Heater Return Pipe

TSB-83-164-FTL

► New Cascadia

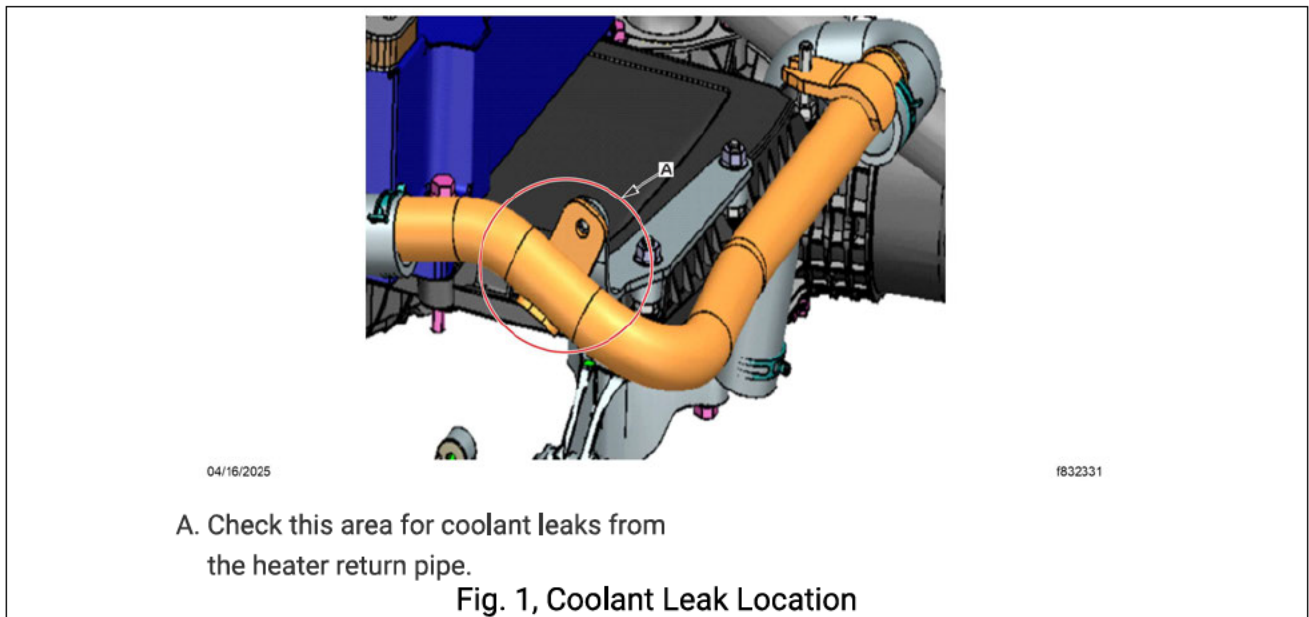
The field received complaints about obvious coolant leaks on the heater return pipe from the weld-on bracket that attaches to the engine bracket. This condition is observed most often on vehicles equipped with DD13 engines. This service bulletin is applicable when there is visible coolant leakage from the tubes and engine side.

1. Inspect the front right-hand side of the DD13 engine heater return pipe for coolant leakage. See Fig. 1.

2. If coolant leaks are found, drain or adjust the coolant level as required.
